Technical Service Information

THM 4L80-E/4L80-EHD NEW SHIFT SOLENOID ASSEMBLIES AND PRESSURE CONTROL SOLENOID

Figure 1

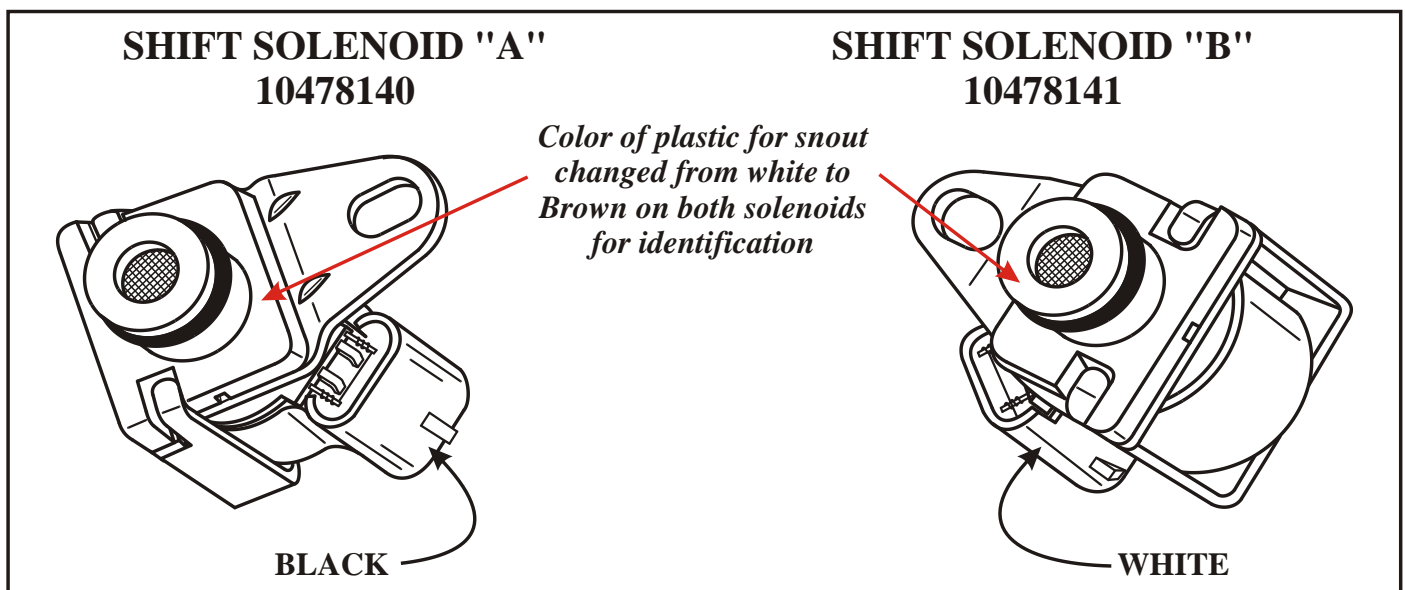
- (1) SHIFT SOLENOID "A" - Revised plastic material in the seat area, and connector is still Black in color, but color of plastic for snout where the "O" ring goes changed to Brown instead of the previous White, for identification purposes (See Figure 1).
- (2) SHIFT SOLENOID "B" - Revised plastic material in the seat area, and connector is still White in color, but color of plastic for snout where the "O" ring goes changed to Brown instead of the previous White, for identification purposes (See Figure 1).
- (3) EPC SOLENOID - Revised (Larger) micron in the solenoid screens for improved operation in cold ambient temperatures (See Figure 2).
